# INFORMATION NOTE

N° 058/15

## Reduction of the data matrix code (DMC) marking size affecting dedicated packages.

- DMC Laser marking size:

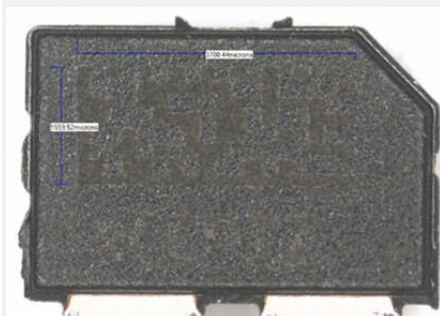
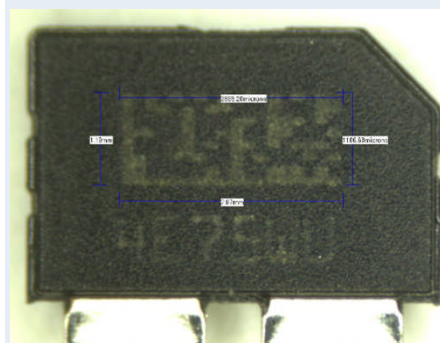
DMC laser marking with a size of 3700 micron x 1600 micron.

DMC laser marking with a size of 2900 micron x 1200 micron.
